CONNECTION ASSESSMENT & APPROVAL PROCESS

PRELIMINARY ASSESSMENT REPORT: 3rd Addendum

*For the Proposed 600MW Portlands Energy Centre Project
by Ontario Power Generation Inc. at Hearn GS.*

CAA ID No. 2001-040

DIAGRAM 15

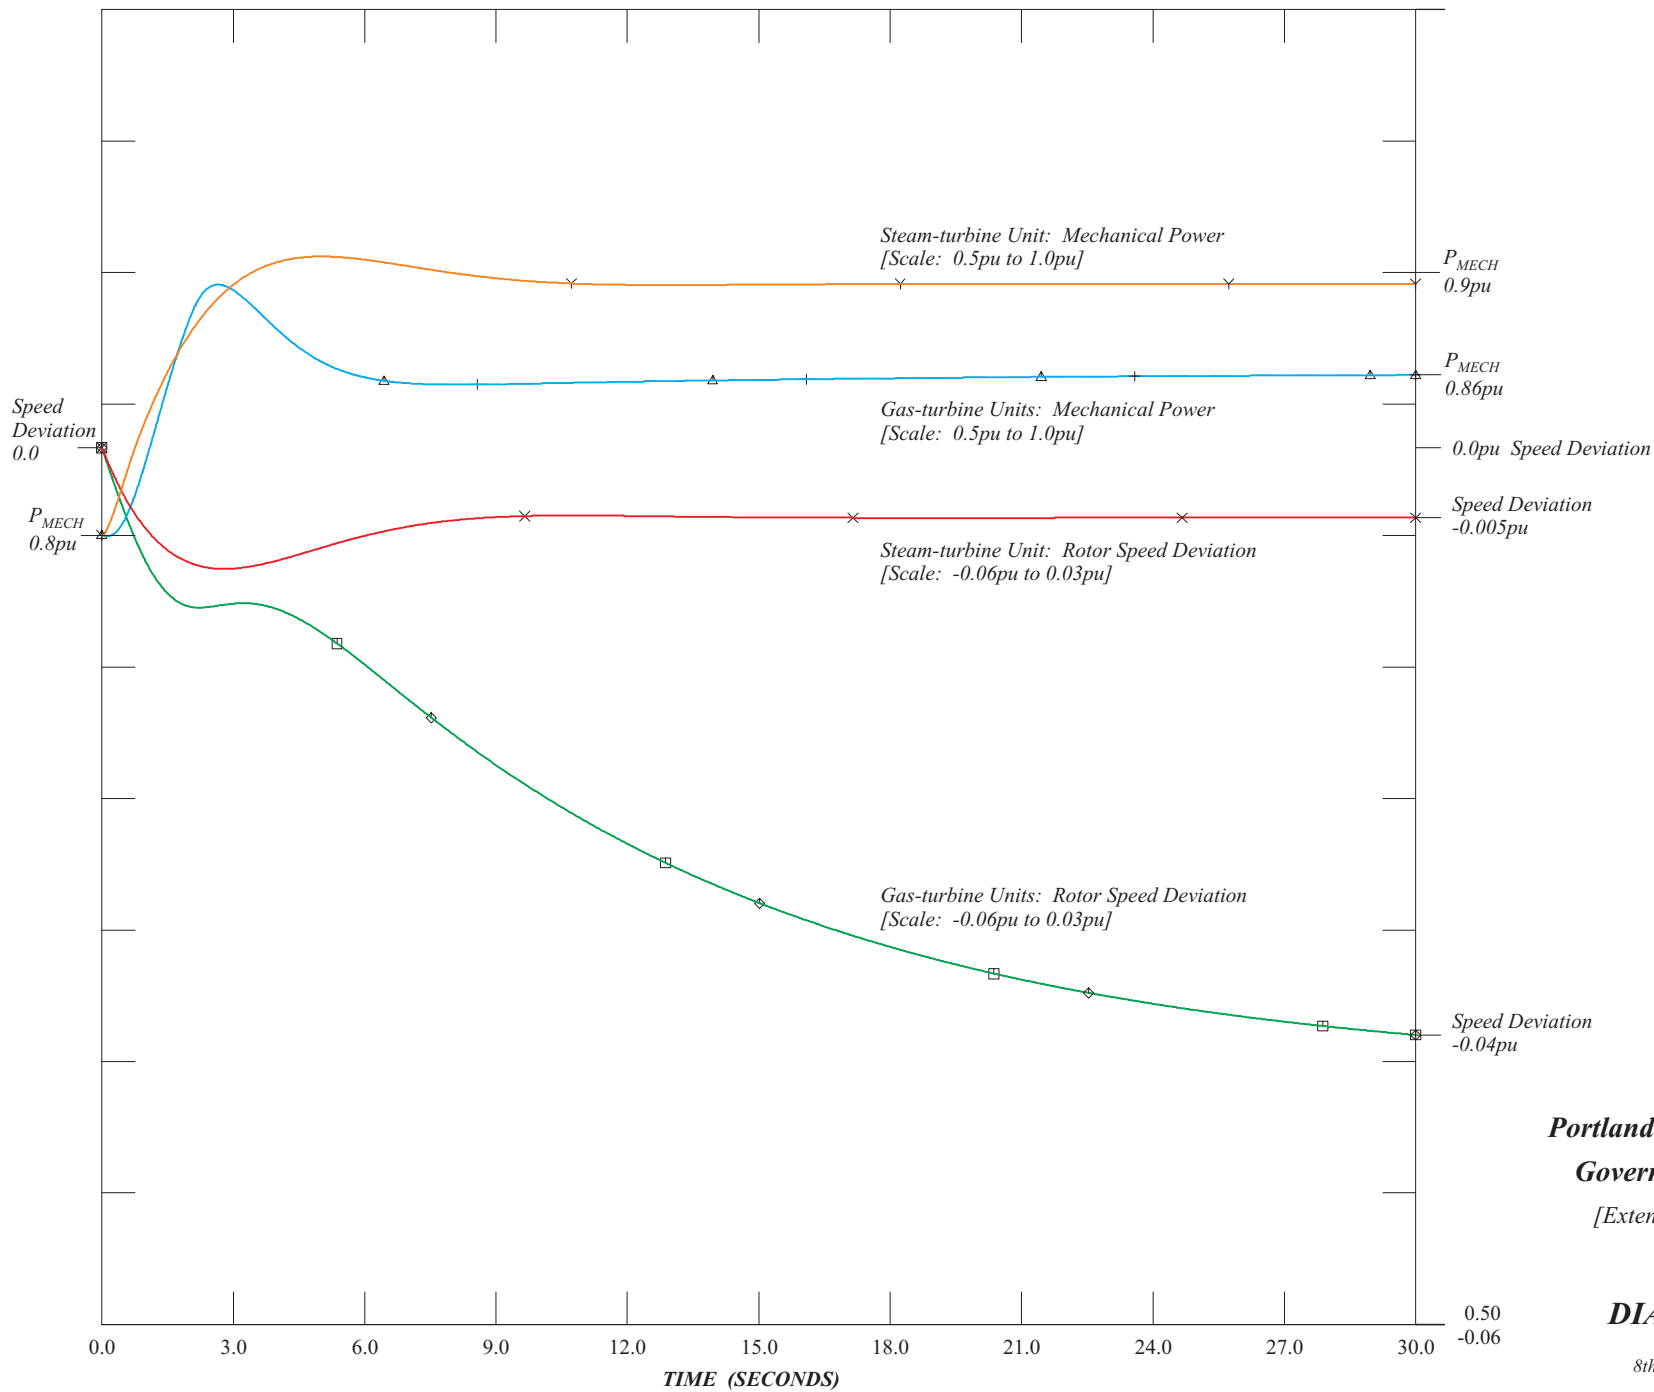
Since the deviation in the speed of the gas-turbine units is still shown to be increasing at the end of the 10 second period following the application of the initial step-change in the loading, the response has been re-plotted for a 30 second interval, together with a change in the scale used for the rotor speed deviation. The revised plot for the extended period is shown in Diagram 15.

While the response of the governor on the steam-turbine would be acceptable to the IESO, the response shown for those governors on the gas-turbines would not be acceptable. Diagram 15 shows that the gas-turbine governors would not be able to sustain a 0.1pu change in the loading and that the speed of the gas-turbines units would decline by 0.04pu. This means that if the gas-turbine units were to be operated in isolation and be subjected to a 0.1pu increase in their loading, the frequency would be expected to fall by 2.4Hz.

- v. Similarly, since the settings proposed for the governors on the gas-turbines units have been shown to result in an unacceptable performance, the IESO requires revised governor settings to be implemented for the gas-turbine units.
